Subject: 45 Lantana Avenue, Wheeler Heights NSW 2097 DA 2020/1743 WRITTEN
SUBMISSION: LETTER OF OBJECTION Submission: Moss & Walton

SUBMISSION: MOSS & WALTON
a written submission by way of objection to DA 2020/1743

Re:
45 Lantana Avenue, Wheeler Heights NSW 2097
DA 2020/1743

Blue arrows defining the privacy location breaches

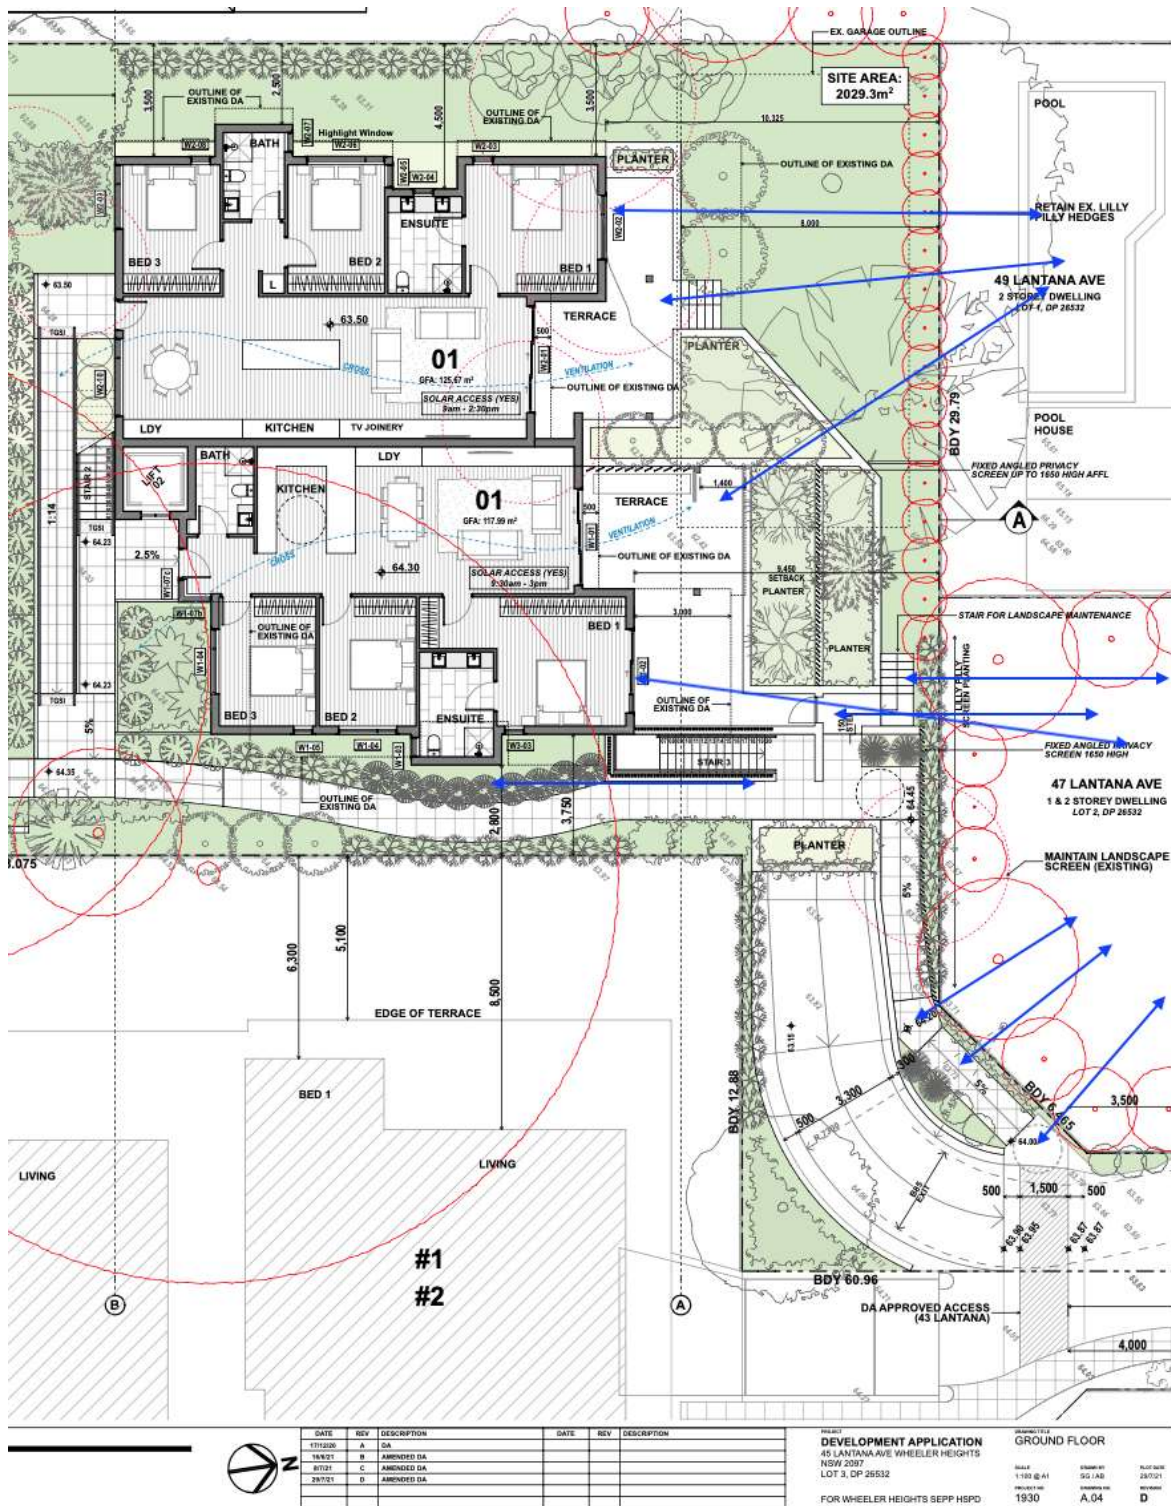
We bring to Council's attention multiple privacy breaches, that are a direct result of poor design. We now have passing bays without adequate screening to neighbour's POS, substantial bin enclosures on property boundaries and onto neighbour's POS, elevated entrance walkways looking directly into neighbour's POS, elevated terraces from units looking directly into neighbour's POS, elevated stairs looking directly down into neighbour's POS, and a flurry of 3m high privacy screens that create unacceptable bulk and scale position very close to our boundary that cause other amenity loss including solar loss.

The spatial arrangement of the proposed development to design 2m high elevated entry approaches, and 2m high elevated terraces on or near neighbour's boundaries is poor design. There is inadequate width in the entry zone to allow for passing bays, and no zone for a suitable privacy landscape zone to protect neighbour's POS. Refuse storage is inappropriately located.

We object to the latest amended plan, Site Plan Drawing A02 rev C, dated 9 July 2021. [attached]

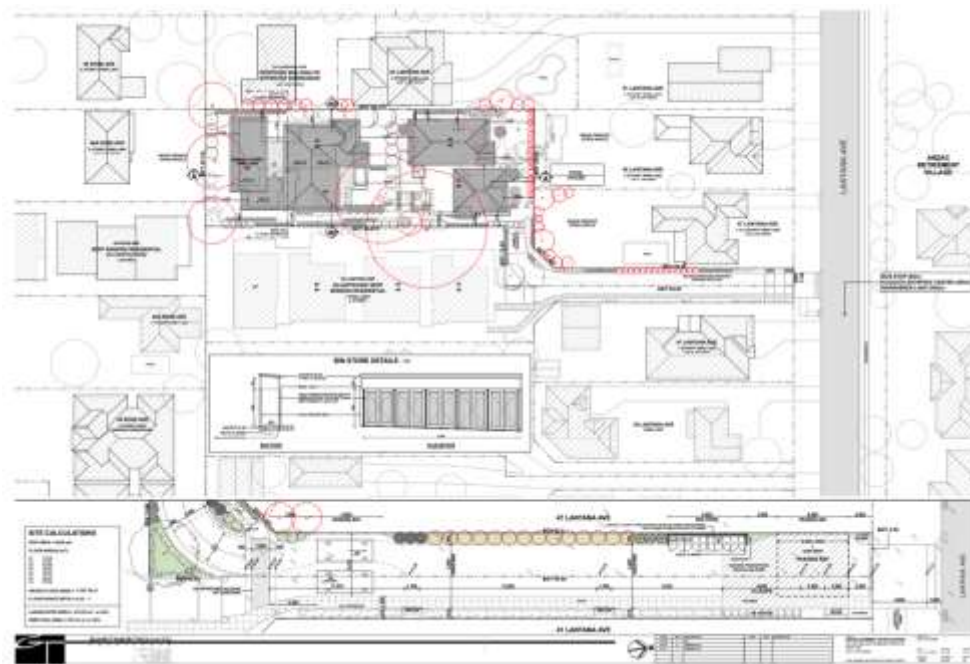
Council will note that the 1:100 drawing, and the 1:250 drawing do not accord.

The 1:100 drawing shows two Passing Bays immediately adjacent the boundary of 47 Lantana Avenue.

The Northern Passing Bay removes the 0.9m deep soil landscape zone, that was providing privacy screening to 47 Lantana Avenue. The Northern Passing Bay also is immediately adjacent letter boxes and bins to be used by HSPD residents. This is totally unacceptable.

The Southern Passing Bay removes the 0.9m deep soil landscape zone, that was providing screening to 47 Lantana Avenue. The Southern Passing Bay now has no landscape privacy screening to the private open space facing 47 Lantana Avenue. This is totally unacceptable.

The Garage Bin Store is now set 1m away from the opening bedroom windows of 47 Lantana Avenue. The smell and noise from such a large garbage area set immediately adjacent opening neighbours windows is totally unacceptable. The bin store needs to be relocated to within the basement.
